SERVICE LETTER #42

SUBJECT: Center Firewall Section

APPLICABILITY: All Series 5 Engine Installation Kits shipped prior to 31 November 1994

Figure 1
Center Firewall Measurement Locations

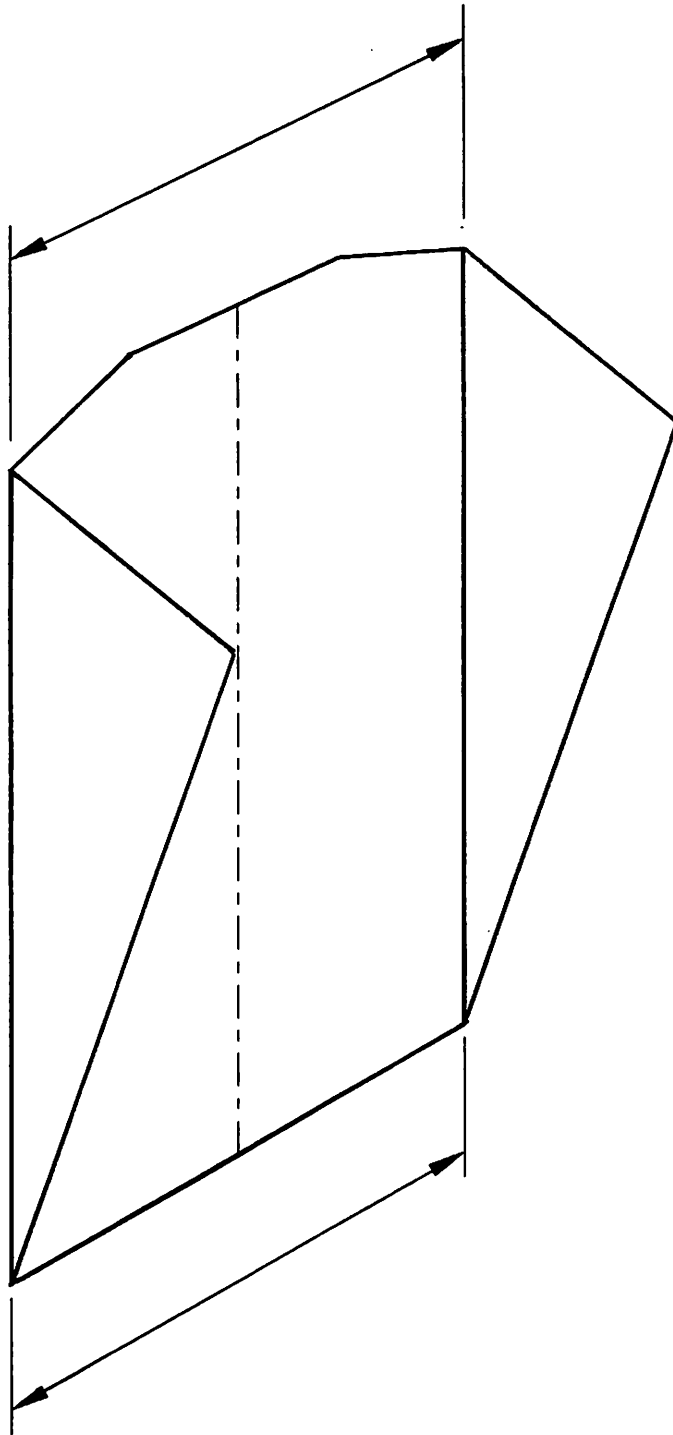
It has been brought to our attention that some 1400 lb Series 5 engine component kits have been sent out with a version of P/N 42729.000 Center Firewall which was originally designed for the 1200 lb gross weight Vixen. If you have received one of these older sections, the remaining components of the firewall will not fit together properly.

To determine which version you have, measure the distance between the two walls at the points indicated in Figure 1. If the two distances are the same (i.e. the sides are parallel), the part is the correct version. If the two measurements are significantly different, indicating the the bottom is approximately 1 inch wider than the top, call our Customer Service Department at 208-466-1711 for a replacement part of the correct size.
